Highgate School – Dyne House – Carbon Management Planning Responses

On 10th April 2024, Haringey Council provided a Carbon Management Response (REF: HGY/2023/0328) which confirmed that the carbon management team would object to the application as submitted. The response detailed a number of concerns and queries in relation to the carbon performance of the proposed development. A meeting was held 10th March 2025 between AECOM, Highgate School, Haringey's Carbon Management team and the Case Officer to discuss the responses. AECOM has liaised with the design team in order to respond to the concerns raised. The response tracker below contains the concerns and queries raised by Haringey council and the design team responses to these.

Response Tracker

Figure 1 Energy demand breakdown for Dyne House

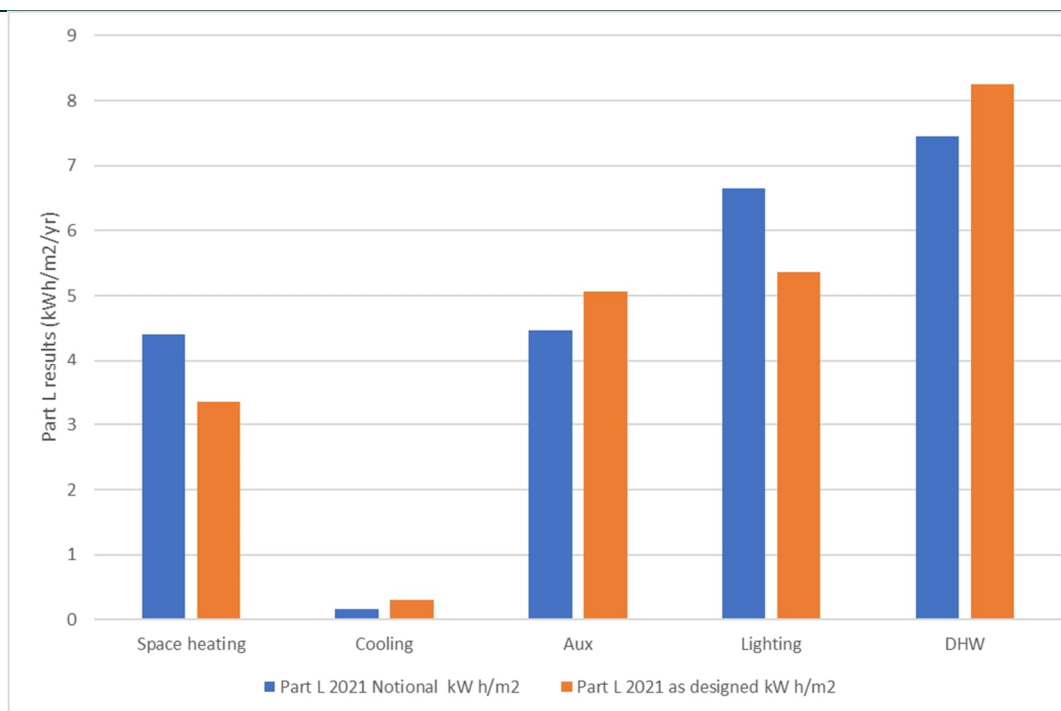
4. The cooling demand is double the notional cooling demand. Please provide a clear explanation of why it is not possible and outline the implications for building design.	Whilst cooling demand is higher than for the notional building, the overall energy demand is very small, representing just 1.4% of the proposed building energy demand, as shown in the Figure 1 below. Therefore, there is limited potential for further carbon savings.

As outlined in section 4 and Appendix E (overheating report) of the energy statement, natural ventilation has been preferred in all suitable spaces and passive design measures incorporated into the design to reduce cooling demand and overheating risk. Only spaces with specific requirements (such as server rooms and the auditorium) or rooms which would otherwise overheat (for example on the south facade of the roadside building where noise, acoustic, safety and air quality considerations prevent large window openings) are proposed to have cooling. The cooling demand is to be met 100% through the ground source heat pump system (GSHP).

Figure 2 Natural Ventilation with Heat Recovery Strategy (Front Building)

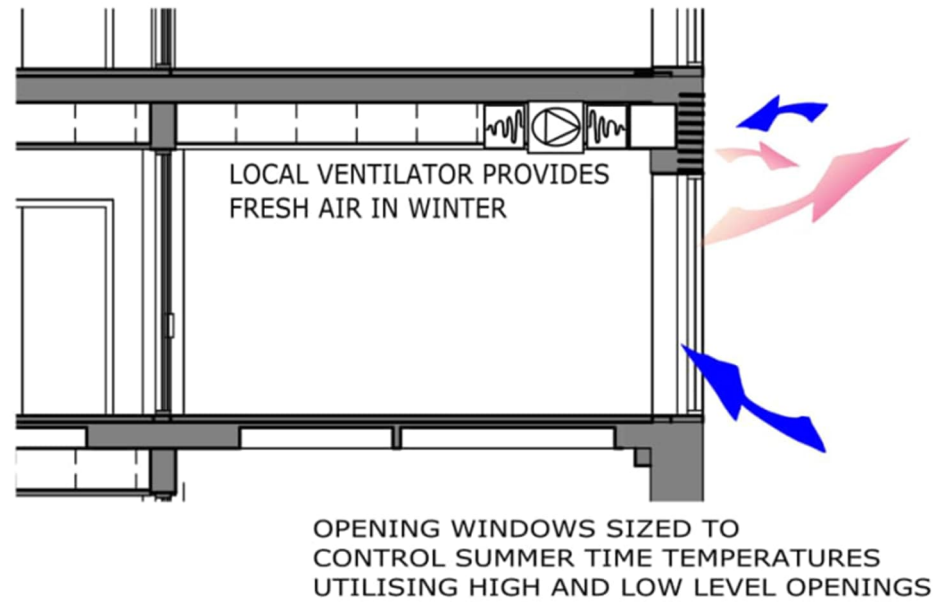
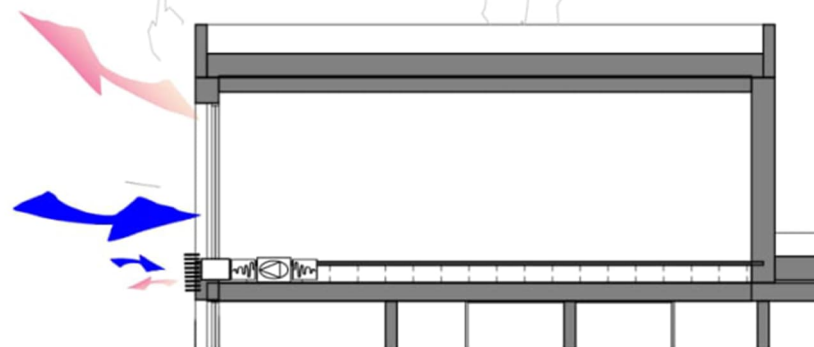
7. Please identify on a plan where the MVHR units will be located within the dwellings. The units should be less than 2m away from external walls. This detail can also be conditioned.	The MVHR units are located within the floor void or ceiling voids of rooms as appropriate and next to the external facade to allow of local fresh air supply to the classrooms. The images below show typical cross sections of rooms which incorporate MVHR:

Appendix 1 provides a section of the building indicating possible service zones for MVHR units.

Figure 4 Shading details of Dyne House site

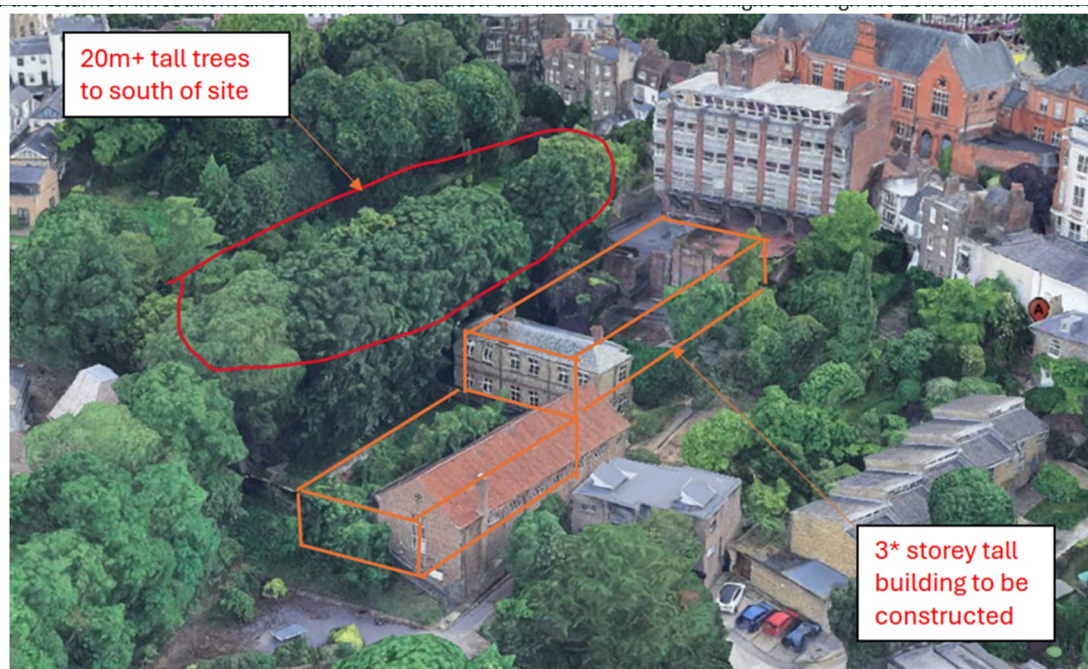
11.	Please provide some commentary on how the remaining available roof space has been maximised to install solar PV. Has your feasibility shown that other roofs will not be viable? Will they be used for other purposes? Living roofs can also accommodate solar PV and will be ideally co-located to reduce the overheating risk of solar PV panels.	PV has been provided on all suitable roofs of the proposed development to maximise renewable energy generation in line with London Plan policy. This is the roof of the tall block adjacent to the road, as shown in drawings in section 6.1.2 of the energy statement. As outlined in the energy statement, other areas of the building are significantly lower as the site slopes away from the road and the buildings at the rear have fewer storeys. The potential to include PV on roof areas to the east of the Dyne House building has been reviewed (above the Auditorium, Bridge Link and Rear Block). As shown by the Google Earth image below and the Appendix 2, the site drops down significantly towards the Highgate Bowl with a difference of 17 m between road level at the front of Dyne House and the Parade Ground at the eastern extreme of the site. The roof levels of the buildings to the back of the site (Auditorium, Bridge Link and Rear Block) have been designed to be low level (max 3 storeys above ground level) to avoid visual intrusion to the surrounding properties. This aspect of the design, combined with the tall mature trees along the southern boundary means that these roofs are heavily shaded and not suitable for PV.

The heavy shading caused by the 20 m+ tall trees along the southern boundary of the site will significantly reduce the amount of sunlight which reaches the roof areas. PV panels rely on direct sunlight to generate energy efficiently, prolonged shading leads to lower energy production and compromised performance. The reduced sunlight exposure would result in a much lower energy output. Installation and maintenance costs might outweigh the benefits of minimal energy generation, leading to a very inefficient PV system in these areas. Reduced efficiencies and electricity generation would also increase the carbon payback period of the PV panels.

Considering the Council's comments made at meeting (1003/2025), a further review was undertaken of the roof area to the very east (on the Rear Block) where it adjoins the Parade Ground to determine if there was potential for PV to be installed there. Based on a desktop review, it is seen that the eastern section of the site would also receive significantly reduced sunlight and would not be suitable for PV panels.

Further, the space available on the top of the 6 storey building Dyne House at the front of site was reviewed with the aim of adding additional PV panels. A more detailed analysis of the space available confirmed that a further 26 m² of panels could be accommodated on the roof of the building.

Figure 6: Proposed location of the GSHP boreholes (energy statement Figure 3).

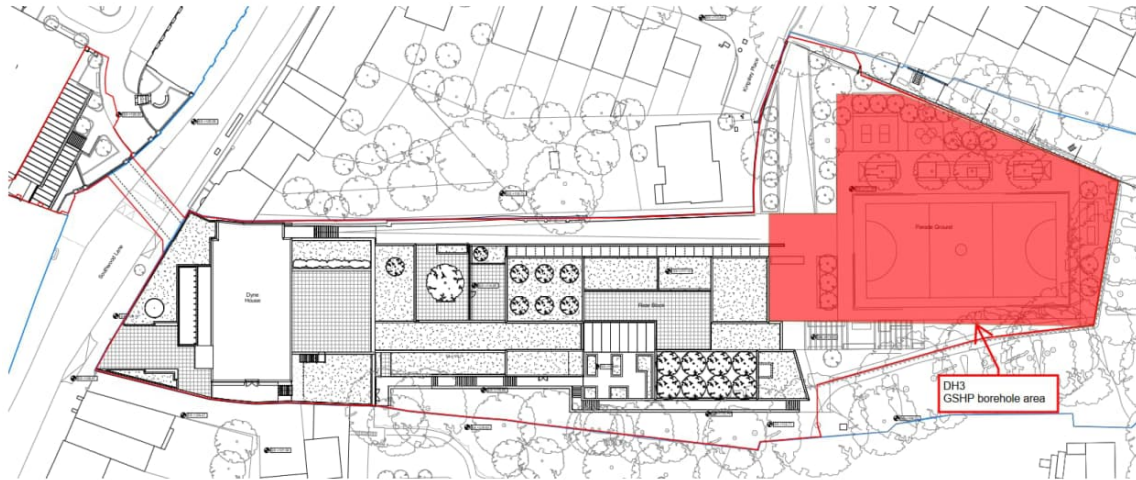
16.	What is the proposed indicative capacity of the GSHP and the thermal storage? Where will this be located? Please ensure this is annotated on plans.	The GSHP system will provide 550 kW_p heating and 250 kW_p cooling. The proposed thermal storage tank size for heating purposes is 9,500 litres, and for cooling purposes is 4,500 litres. As shown in Figure 6 below (Figure 3 in the submitted energy statement), it is proposed that boreholes for the GSHP system are located under the parade ground at the eastern end of the site.

Figure 9 Natural Ventilation with Heat Recovery Strategy (Rear Building)

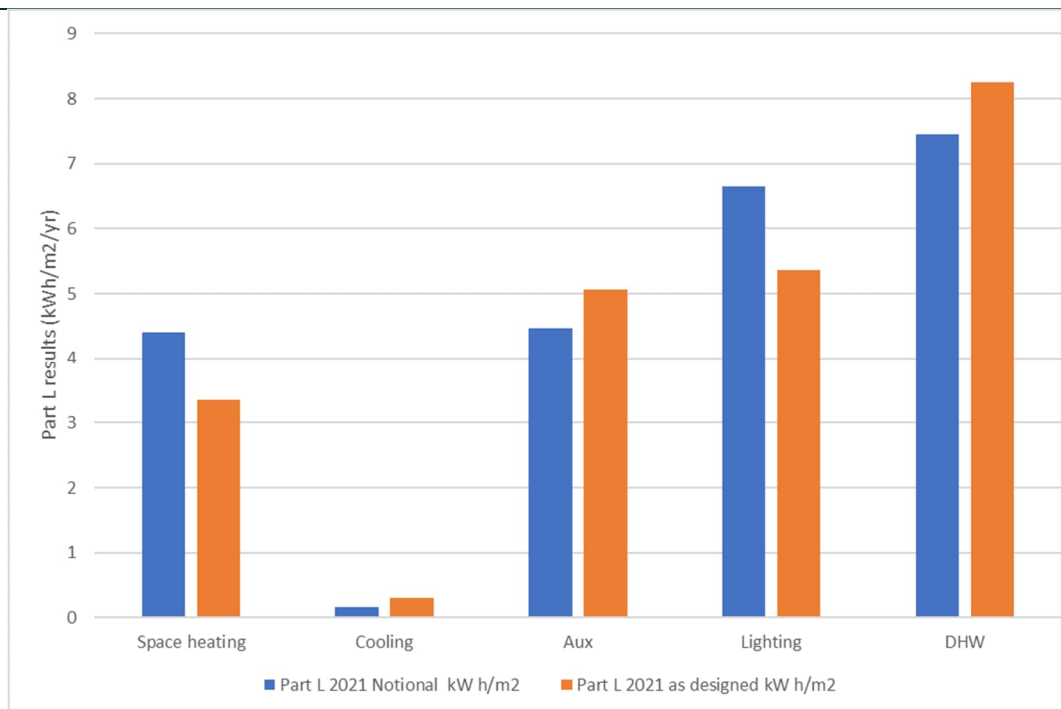
21.	The cooling demand is double the notional cooling demand. Please follow the cooling hierarchy in order and step by step, and first implement all passive measures to reduce the overheating risk and the cooling demand before introducing any mechanical form of cooling. It is unclear why revised opening arrangements were introduced at the end and not	Whilst cooling demand is higher than for the notional building, the overall energy demand is very small representing just 1.4% of the proposed building energy demand, as shown in the chart below. Therefore, there is limited potential for further carbon savings.

As outlined in section 4 and Appendix E (overheating report) of the energy statement, the cooling hierarchy has been followed, natural ventilation has been preferred in all suitable spaces and passive design measures incorporated into the design to reduce cooling demand and overheating risk. Only spaces with specific requirements (such as server rooms and the auditorium) or rooms which would otherwise overheat are proposed to have cooling.

Mechanical cooling is only proposed to areas which would otherwise overheat despite the inclusion of passive measures. In some areas, particularly the 5-storey block at the west of the development by the road, large openable windows would not be suitable for safety reasons. In addition, there are air quality and noise concerns from the location next to the main road. In some other areas, for example music practice rooms, openable windows have been avoided to respond to neighbours' concerns about noise escaping the building. Openable windows are included where these constraints allow.

Figure 11 Natural Ventilation with Heat Recovery Strategy (Front Building)

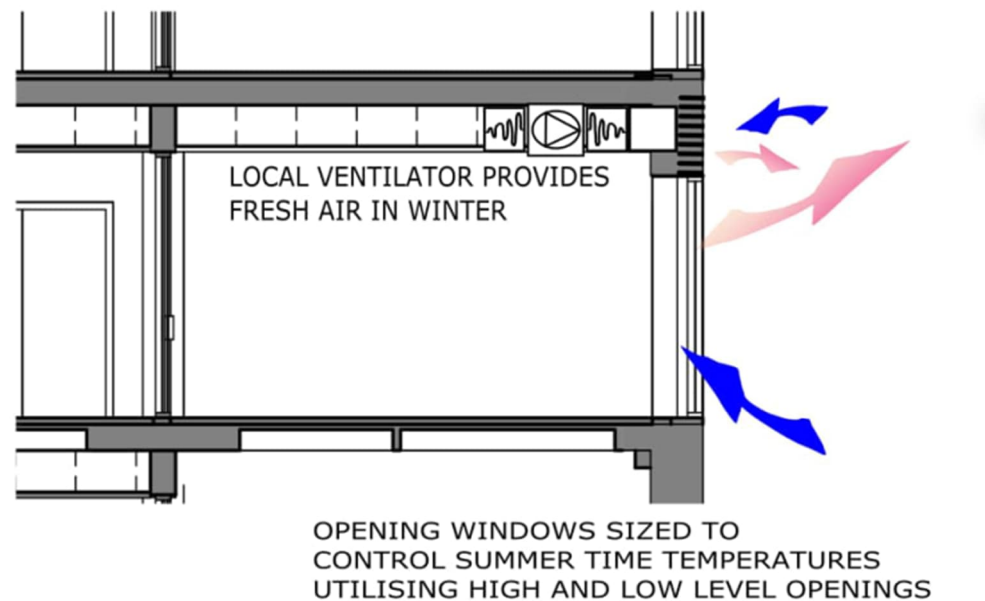
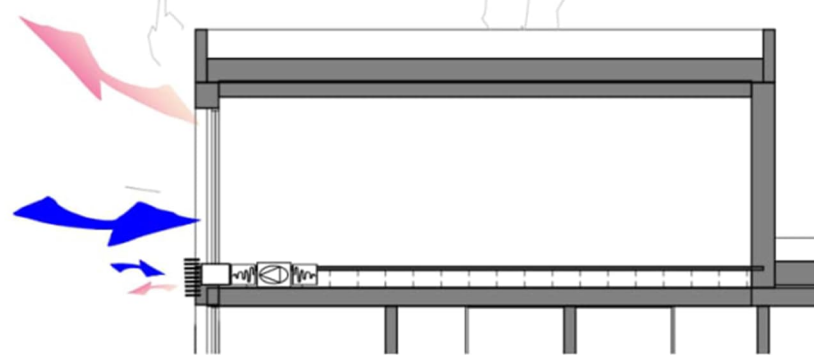
27. Submit a plan specifying the ventilation strategy and overheating risk mitigation strategy, as requested at pre-application stage. For example: Table 6 of the submitted report showing screenshots illustrating baseline (DSY1) results should annotate the names of the different rooms modelled and their ventilation/cooling strategy.

Window openings are sized to provide the required ventilation in summer conditions during the school term. During winter and cooler shoulder months, a localised heat recovering system connected through the façade will provide background ventilation.

The local ventilation system will provide night-time purge during summer to cool the building fabric. The system will utilise the fabric of the exposed slabs to maintain thermal comfort. The windows will be linked to the ventilation system to ensure fans will not run when windows are opened.

Appendix 3 – Visualisation showing shading fins

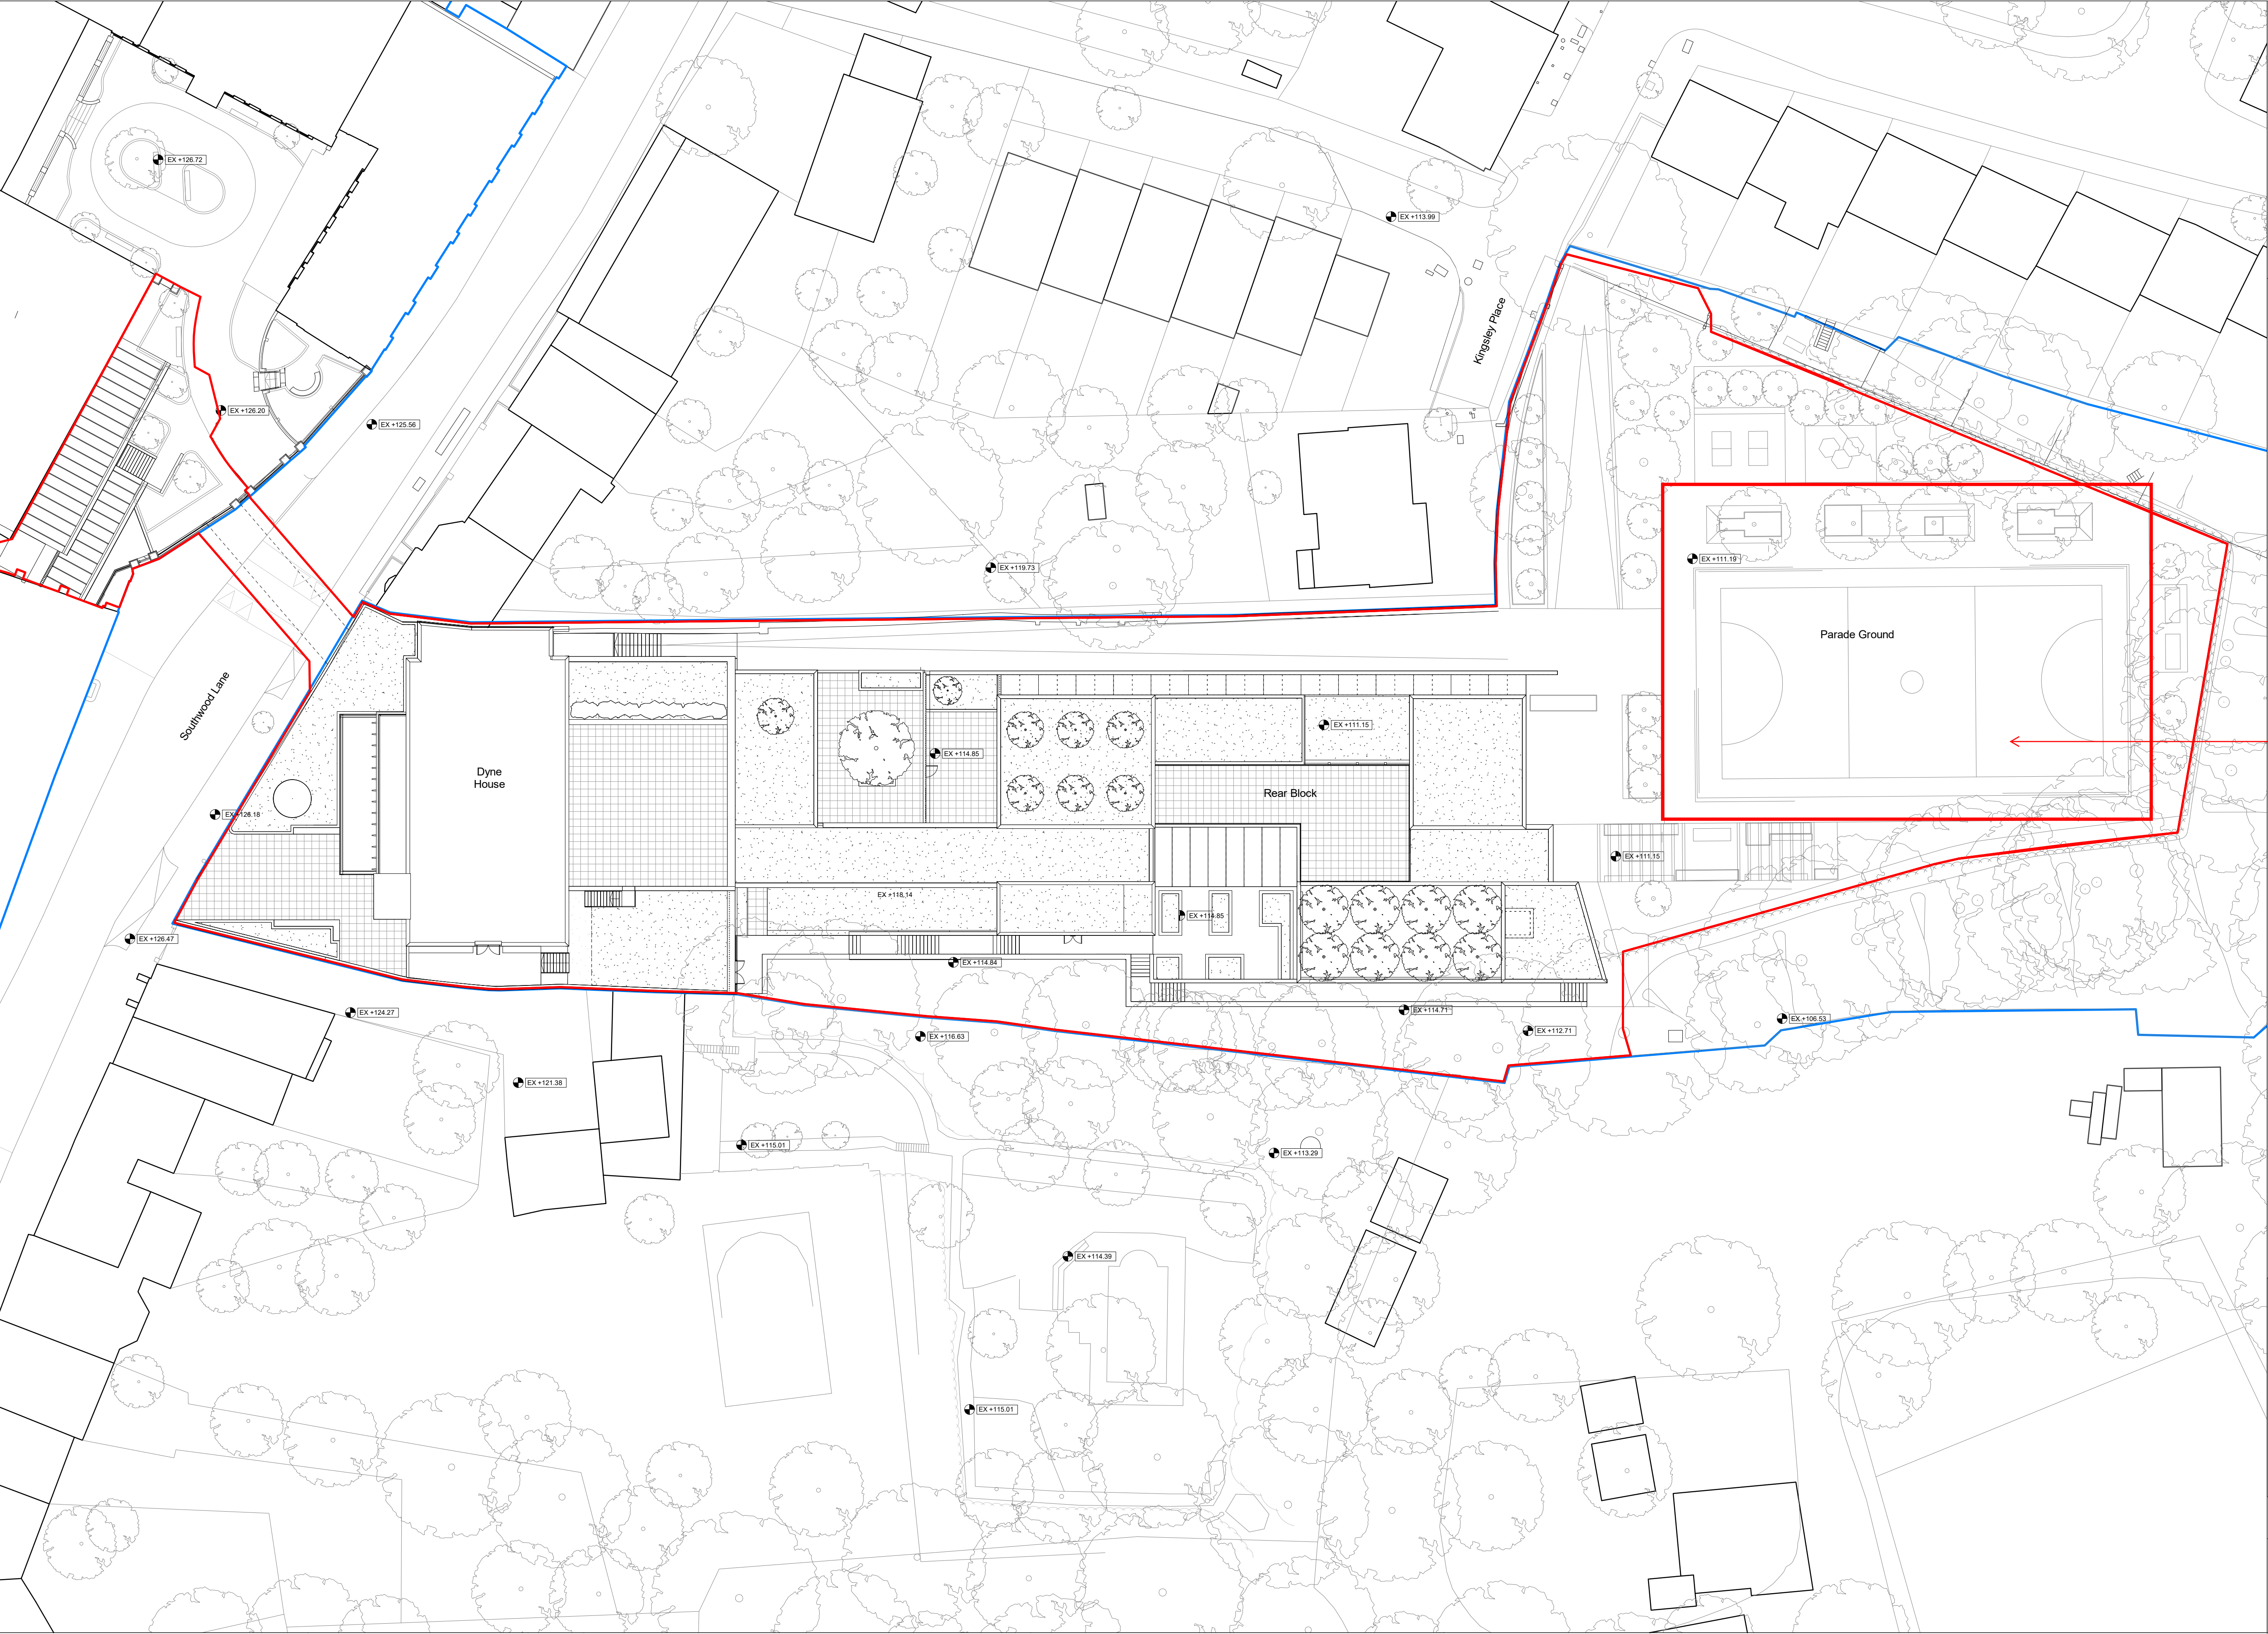
23.	Specify the shading strategy, including technical specification and images of the proposed shading feature, elevations and sections showing where these measures are proposed. Provide the technical specification and images of the proposed shading feature, elevations and sections showing where these measures are proposed.	As outlined above, shading is provided through vertical shading fins to the western façade and through the natural shading from the site topography and nearby tall trees. The fins are a bespoke design integrated to the architecture of the façade of the building. A detailed technical specification has not yet been developed at this stage of the project. The visualisation and section, in Appendix 3 shows the location of the shading fins.
